PSY2 RETAIN TIPS
(as of 05/23/98 at 00:56:36 EDT)

RETAIN Technical Data

PSY2 RETAIN TIPS
Table of Contents - HSF Retain Tips

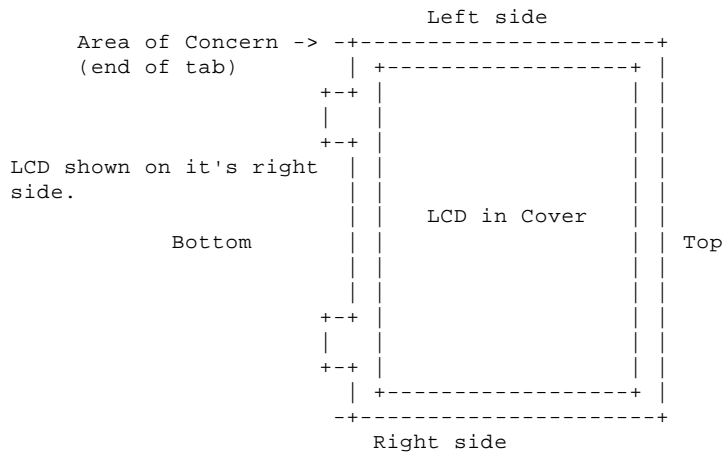
Replace the LCD top cover for cracks at the left hinge area as shown in the PHYSICAL CHECK.

Install a new left hinge during ECA activity, if the hinge is glued to the original LCD cover.

1. Remove and discard the two (2) identified screws.
LCD WITH BEZEL REMOVED

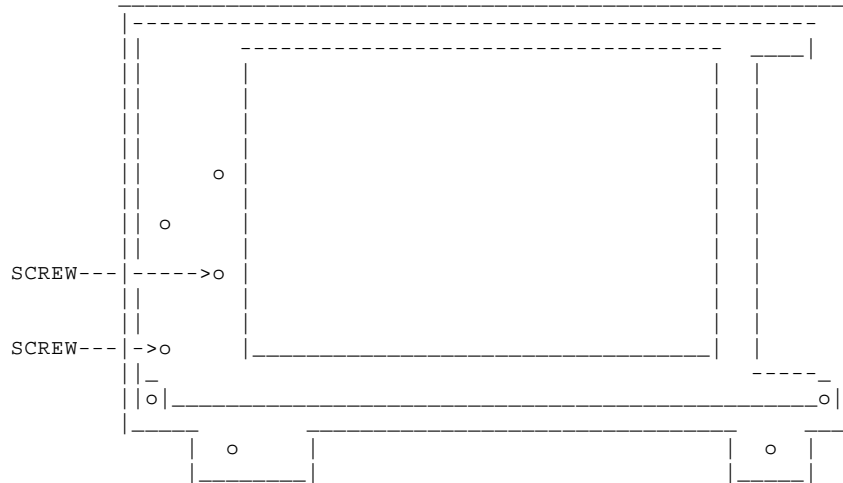
The ECA consists of removing two (2) screws from the card located to the left of the LCD panel. Removal of the screws prevents flexing and subsequent cracking of the connection between the card and the LCD.

2. Place the EC label over the area that contained the screws.
This label has the FRU, EC, and LCD part number on it.
3. Replace bezel and attach using original screws.
4. Install new screw covers.
5. Place the ECA001 label inside the system on the base beneath the battery.

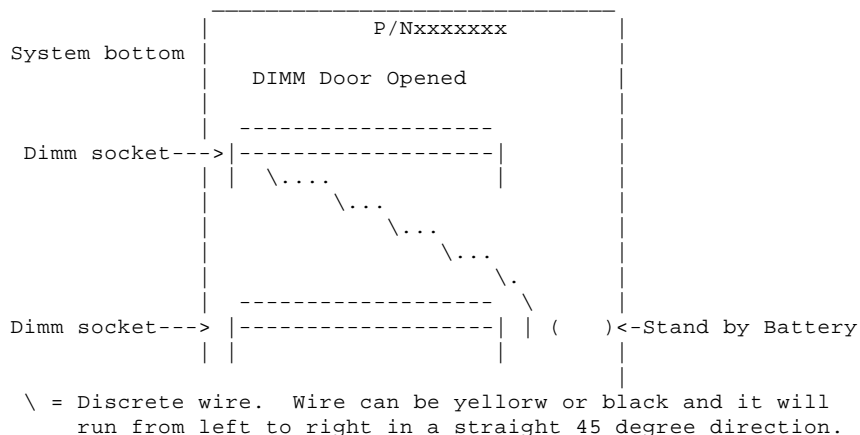
The new level replacement system board will have FRU P/N10L1574 written on a label in same area as the old part number.

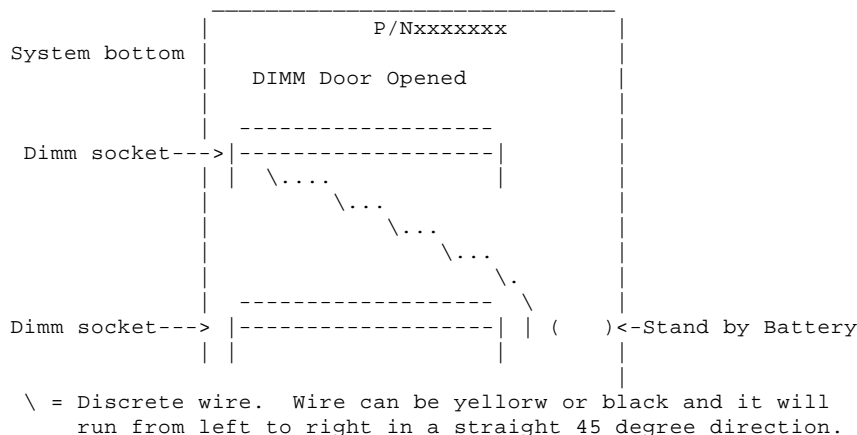
The new level replacement system board will have FRU P/N10L1574 written on a label in same area as the old part number.

PHYSICAL CHECK:

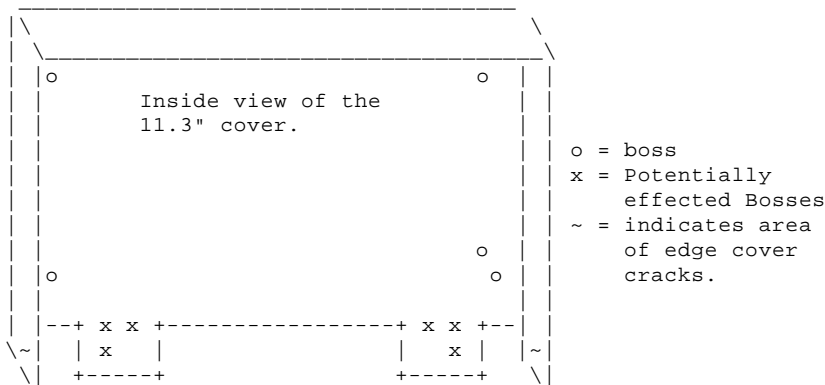
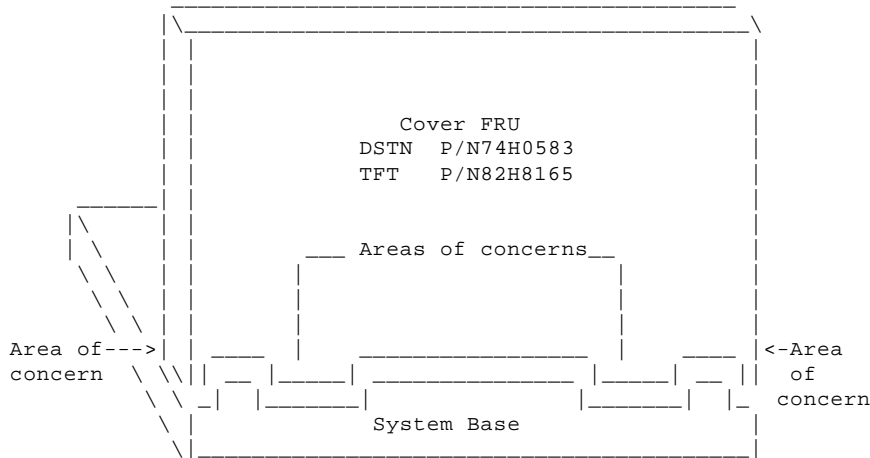
Check for cracks in the hinge area, lower LCD cover edge or in the area of the internal LCD attachment bosses as shown in the following diagrams.

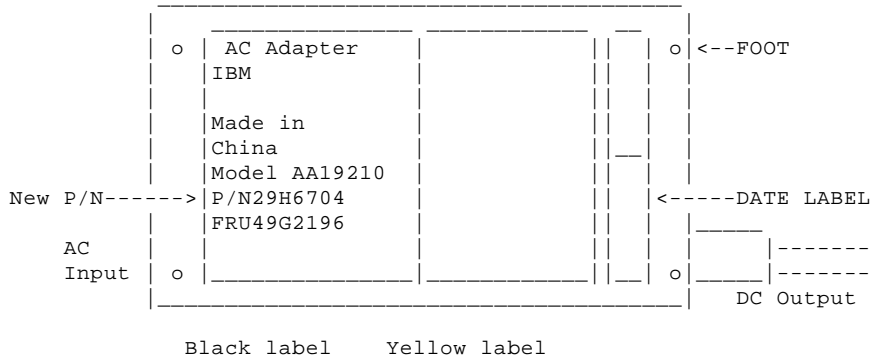
The following line drawing shows an AC Adapter with a black and yellow label on the bottom of the unit. (The bottom has the rubber feet.) NOTE: The date label is located to the right of the yellow portion of the label and the IBM TEST LABEL that indicates a corrected AC Adapter is located to the right of the bar code label.

!!!! AC ADAPTERS WITH NEW P/N29H6704 ARE NOT AFFECTED !!!!

Figure 1.
 The Zeros and the white silk screened dot indicate where to press during installation.

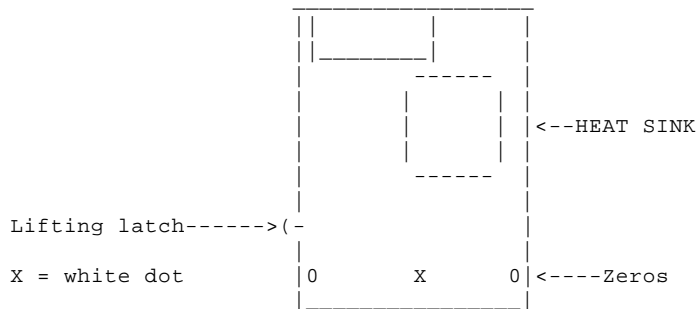
The CPU card pins must all seat simultaneously during installation. To do this place the card over the socket. Then position your fingers at the two corners and on the white silk screened spot at the center of card over the connector. Press down with even pressure until the connector clicks into the socket.
